<b>AMENDMENT OF SOLICITATION/MODIFICATION OF CONTRACT</b>				1. CONTRACT ID CODE		PAGE OF PAGES 1   5	
2. AMENDMENT/MODIFICATION NO. 0002		3. EFFECTIVE DATE 30-Sep-2022		4. REQUISITION/PURCHASE REQ. NO.		5. PROJECT NO.(If applicable)

Summary of changes for Amendment-0002  
LGA DC System and LV Switchgear Upgrades  
Solicitation Number: W912EF22R0001

**Walla Walla District Corps of Engineers**  
 Little Goose DC System and Low Voltage Switch Gear Upgrades

SHEET ID  
VOLUME 2  
E-601

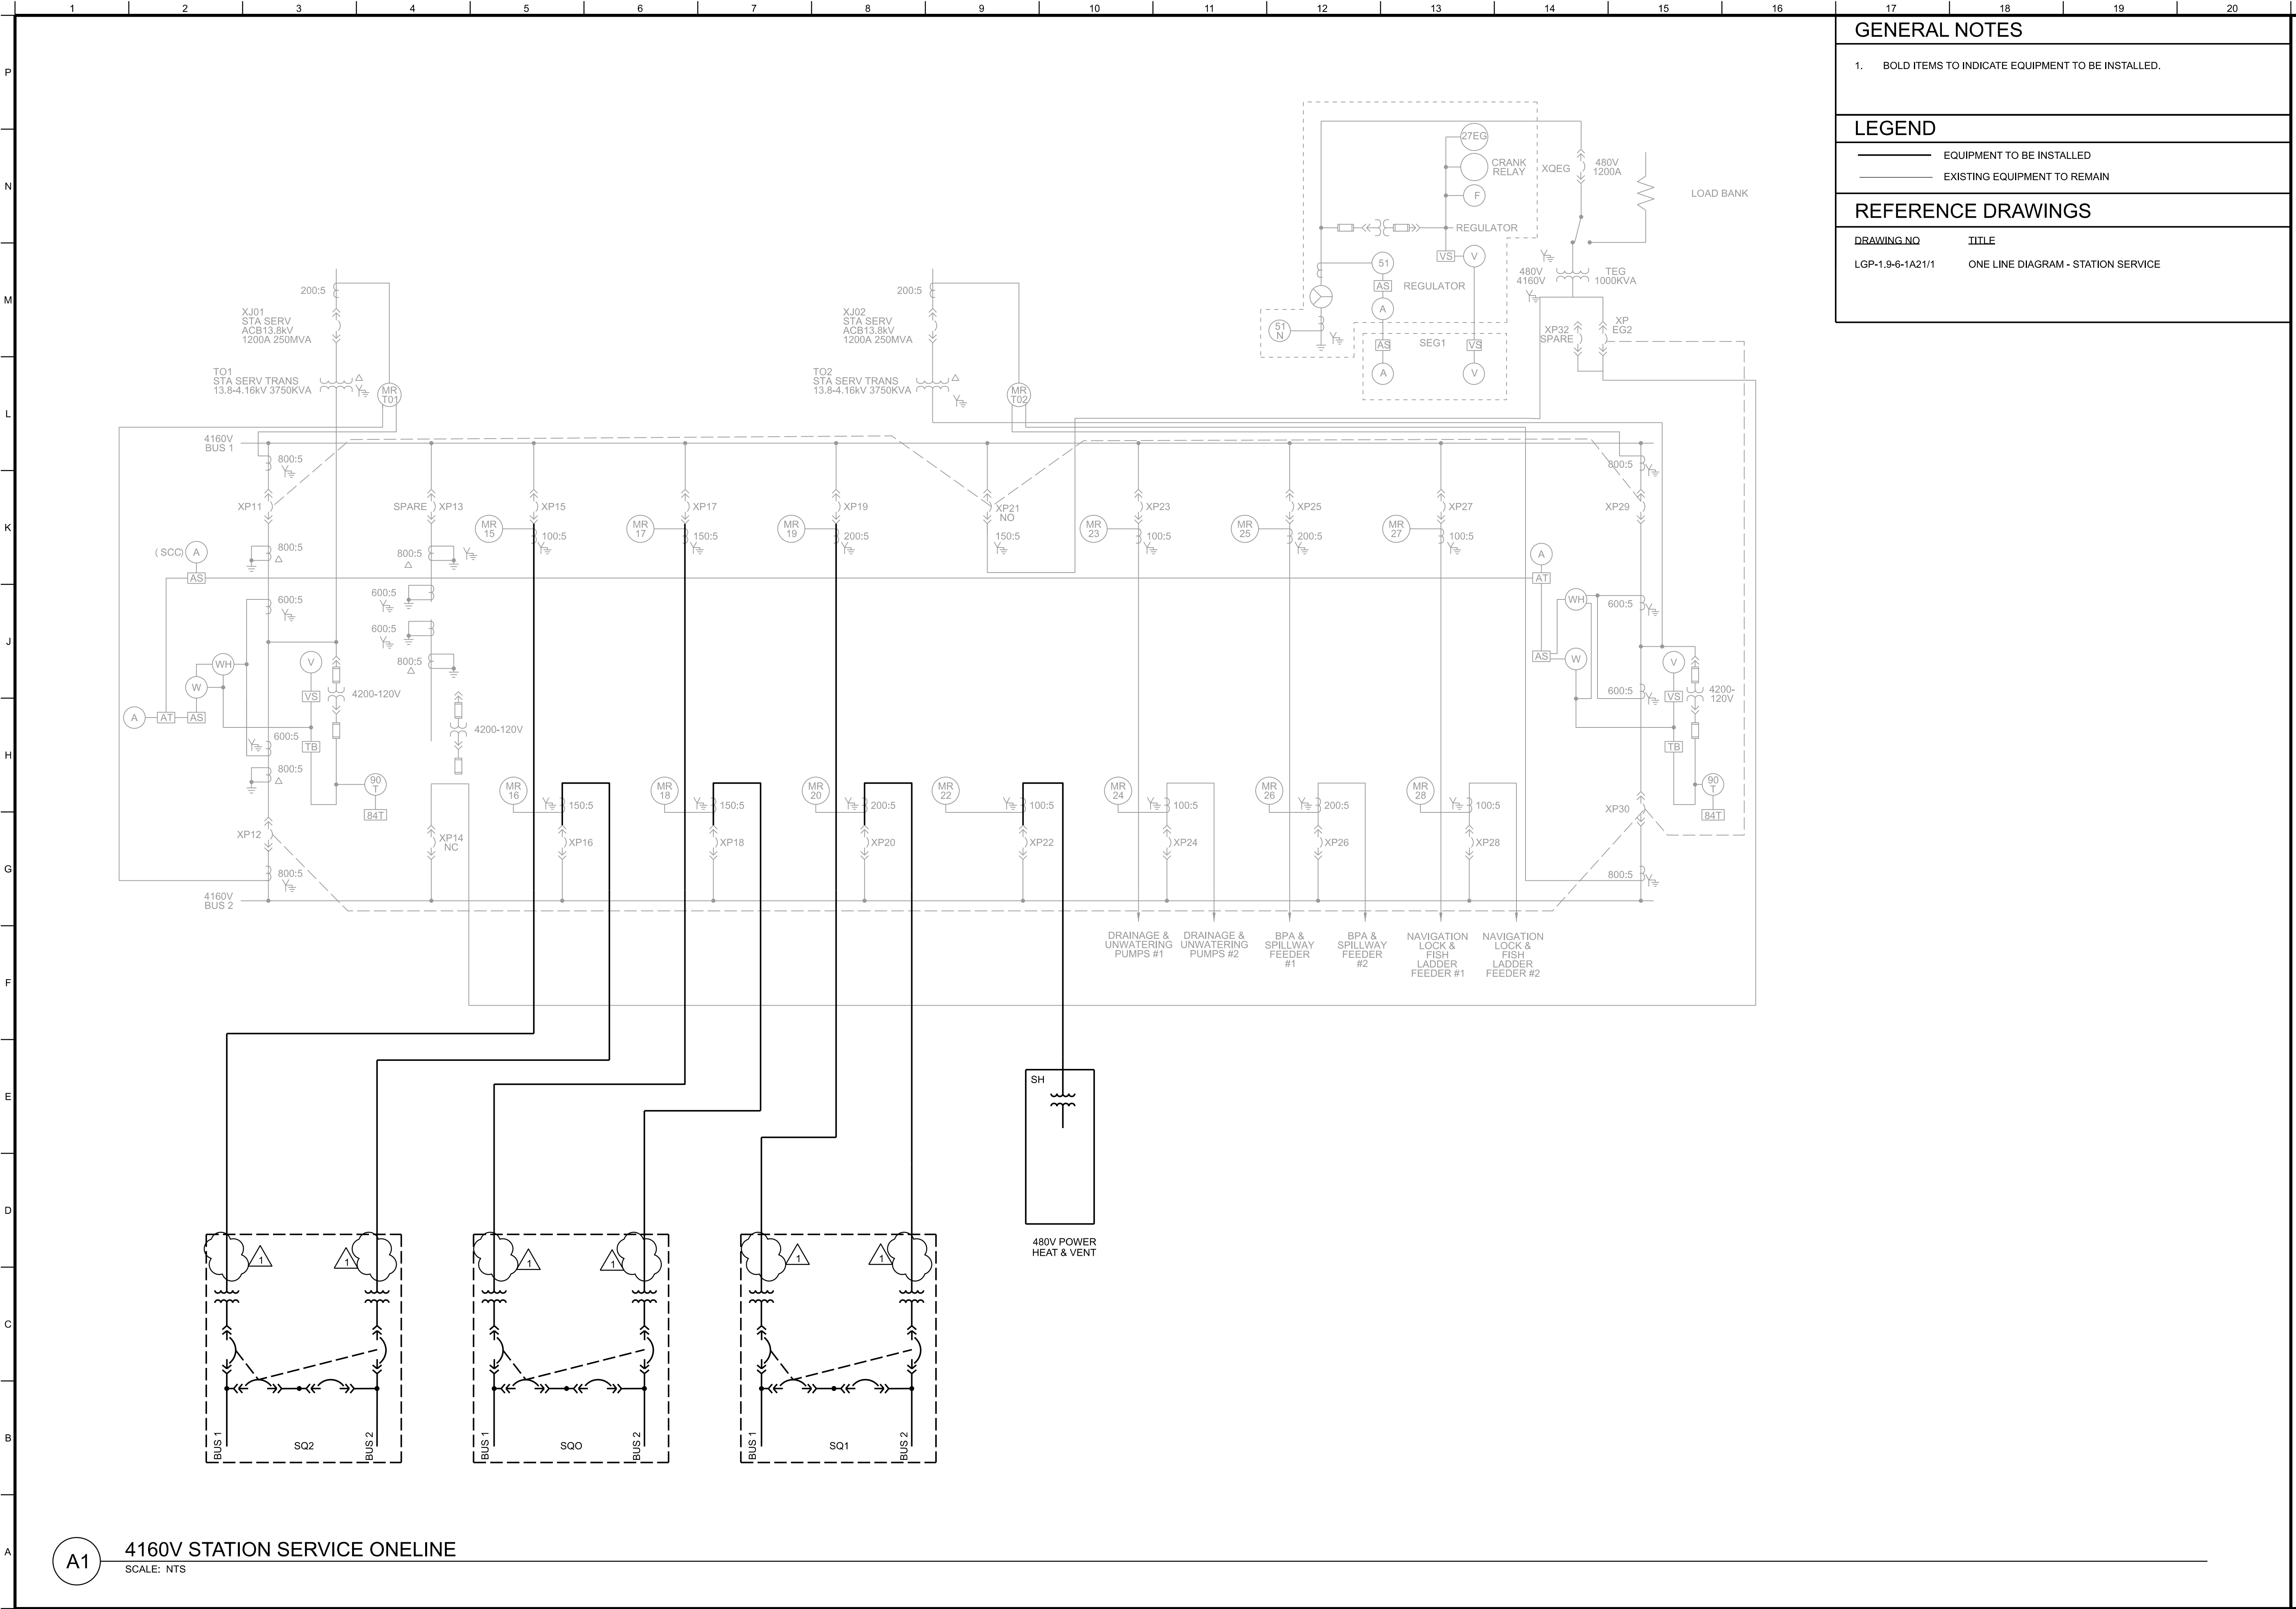
See revised specifications for details.
3. Revised the following Drawings:
  - a. Volume 1 G-007: added Resource Drawings to Index Sheet
  - b. Volume 1 E-505A: Revised Plan Sheet
  - c. Volume 2 E-601: Revised Plan Sheet
  - d. Volume 5 E-301: Revised Plan Sheet
  - e. Added Resource Drawings R-143 through R-156
